Comment

(TDL #162 from D2.1)

1. Some updates are required for D2.2 for moving some of the normative requirements in Annex B to the standard body into 33.2.8.5.1 as requested by TDL #162.
2. As a result from (1), Annex 33B was updated accordingly and became informative

Figure 33B-1—PSE PI unbalance specification and E2EP2PRunb

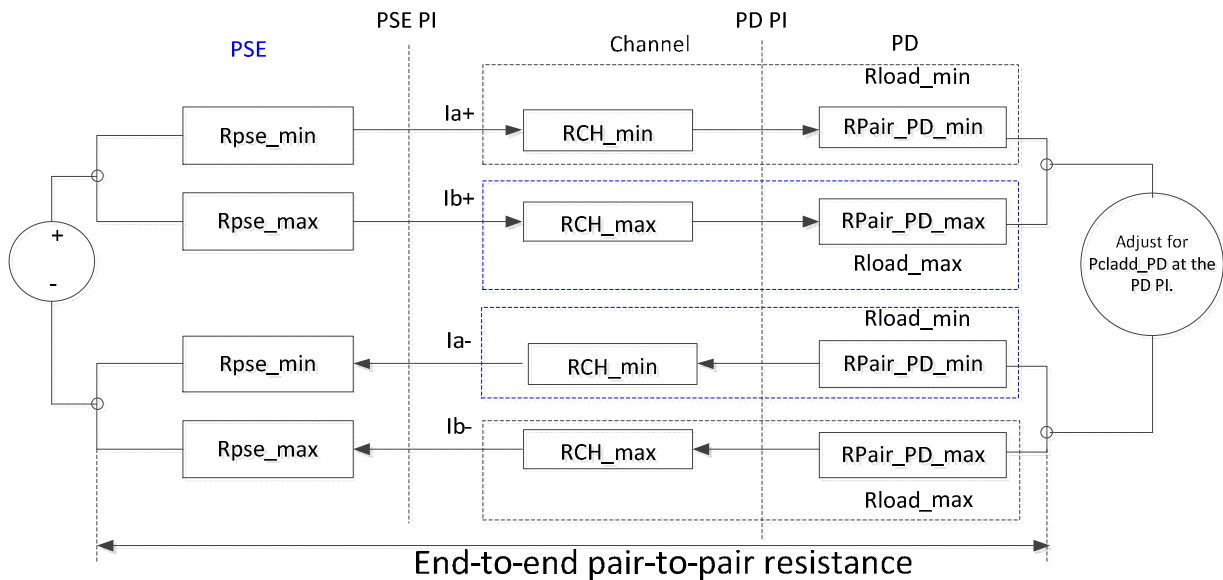
**Move Figure 33B-1 to 33.2.8.5.1 (to this location) with the marked updates.
Update Figure numbers as required.**

R_{Ch} is the maximum value of (RCH_min + RCH_max) as described in Figure 33-B1.

RCH_max is the sum of channel pair elements with highest common mode resistance and RCH_min is the sum of channel pair elements with lowest common mode resistance.

Figure 33B-4—Current unbalance test circuit

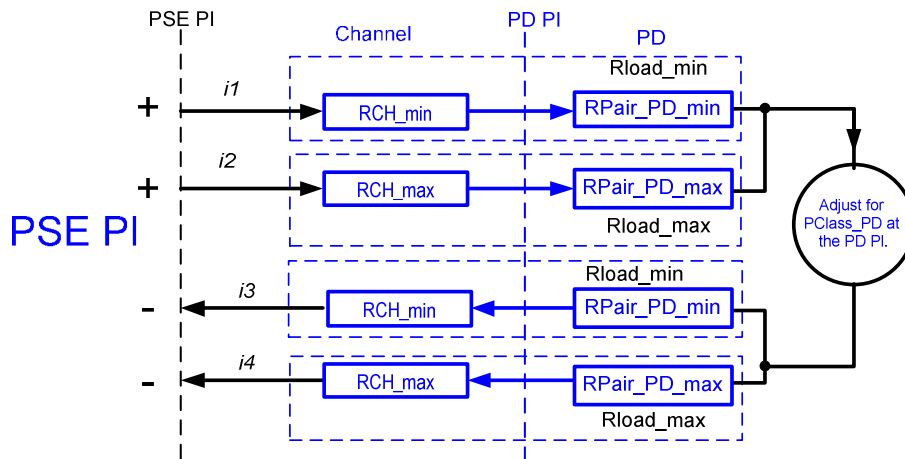
Move Figure 33B-4 to this location with the following marked updates.

- 1) Use R_{load_min} and R_{load_max} from Table 33B-1 for R_{load} at low channel resistance conditions.
- 2) With the PSE powered on, adjust the load to P_{class_PD} .
- 3) Measure I_1 , I_2 , I_3 and I_4 .
- 4) Swap R_{load_max} , R_{load_min} , repeat steps 1 and 2.
- ~~5) Repeat for I_3 , I_4 .~~
- ~~6) Verify that the current in any pair each case~~ does not exceed I_{con-2P_unb} minimum in Table 33-18.
- ~~7) Repeat steps 1-6 for R_{load_min} and R_{load_max} from Table 33B-1 for R_{load} at high channel resistance conditions.~~

Figure 33–39—ICon-2P and ICon-2P-*unb* evaluation model

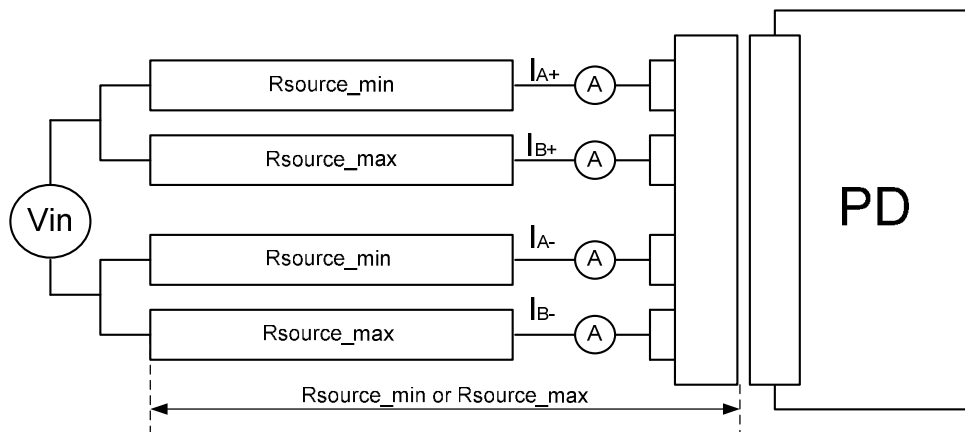
Under all operating states, single-signature PDs assigned to Class 5 or higher shall not exceed ICon-2P-*unb* for longer than TCUT-2P min as defined in Table 33–18 on any pair when PD PI pairs of the same polarity are connected to all possible common source voltages in the range of VPort_PSE-2P through two common mode resistances, R_{source_min} and R_{source_max} , where $R_{source_max}=1.186 * R_{source_min}$ $R_{source_max}=(-0.031 * R_{source_min} + 1.309) * R_{source_min}$, and R_{source_min} are all possible resistances in the range of $0.1680.147 \Omega$ to $5.28.5.568\Omega$ as shown in Figure 33–37.

Under all operating states, dual-signature PDs shall not exceed ICon-2P as defined in Equation (33–8) for longer than TCUT-2P min as defined in Table 33–18 on any pair when PD PI pairs of the same polarity are connected to all possible common source voltage in the range of VPort_PSE-2P through two common mode resistances, R_{source_min} and R_{source_max} , where $R_{source_max}=1.186 * R_{source_min}$ $R_{source_max}=(-0.031 * R_{source_min} + 1.309) * R_{source_min}$, and R_{source_min} are all possible resistances in the range of $0.1680.147 \Omega$ to $5.28.5.568\Omega$ as shown in Figure 33–37.

R_{source_min} and R_{source_max} represent the V_{in} source common mode effective resistance that consists of the PSE PI components (R_{PSE_min} and R_{PSE_max} as specified in 33.2.8.5.1, $V_{Port_PSE_diff}$ as specified in Table 33–18, the channel resistance, and influence of $R_{PAIR_PD_min}$, $R_{PAIR_PD_max}$ specified in 33A.5 as function of system end-to-end unbalance). Common mode effective resistance is the resistance of two conductors of the same pair and their other components, which form R_{source} , connected in parallel including the effect of the system (PSE and PD) total pair to pair voltage difference. I_A and I_B are the pair currents of pairs with the same polarity.

Figure 33A-XX – Common mode Pair-to-pair channel resistance unbalance

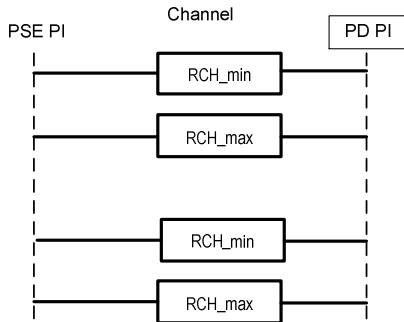
Figure 33A-XX was added to differentiate between R_{ch} term used from PSE PI to PD PI and back and the channel resistance of pair of wires and their connectors from PSE PI to PD PI (one way) that is used in this Annex and all related P2Punb clauses.

Add Figure 33A-XX

Figure 33A-4—PD resistance unbalance elements overview

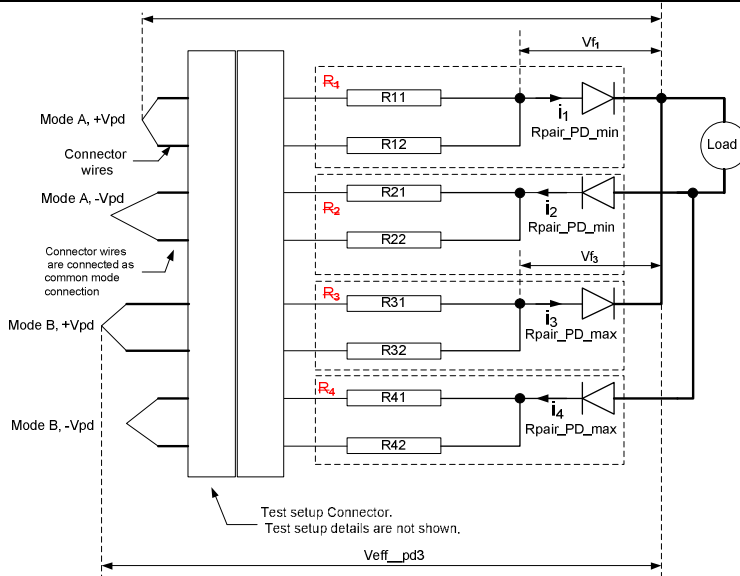
This is not part of the baseline
 We can simplify text and drawing by deleting R1, R2, R3 and R4 from the text and Figure 33A-4 since we have Rpair_PD_min/max definitions already in the drawing and the text.

Figure 33B-1—PSE PI unbalance specification and E2EP2PRunb

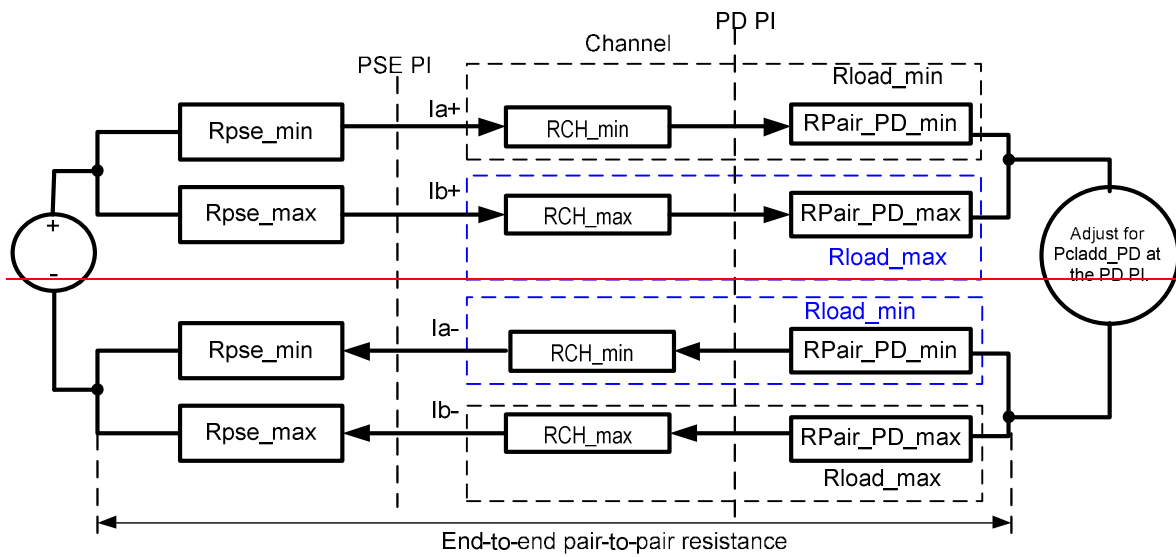
Delete Figure 33B-1. It was moved and updated to 33.2.8.5.1

Figure 33B-3 – Effective resistance test circuit

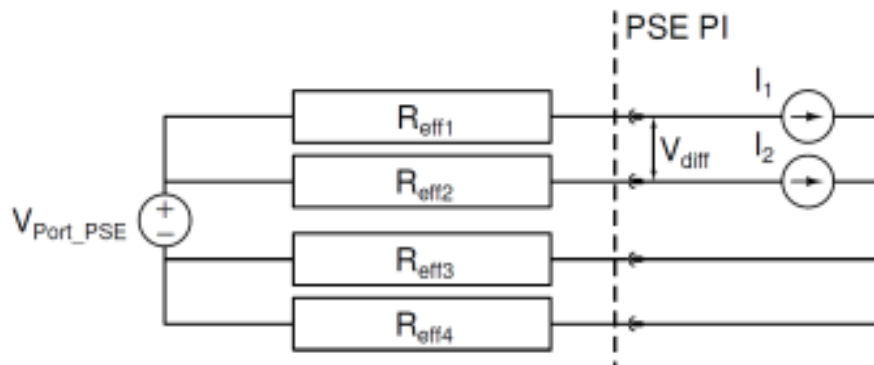
Add to TDL: Ken to verify that the following test model works in simulations
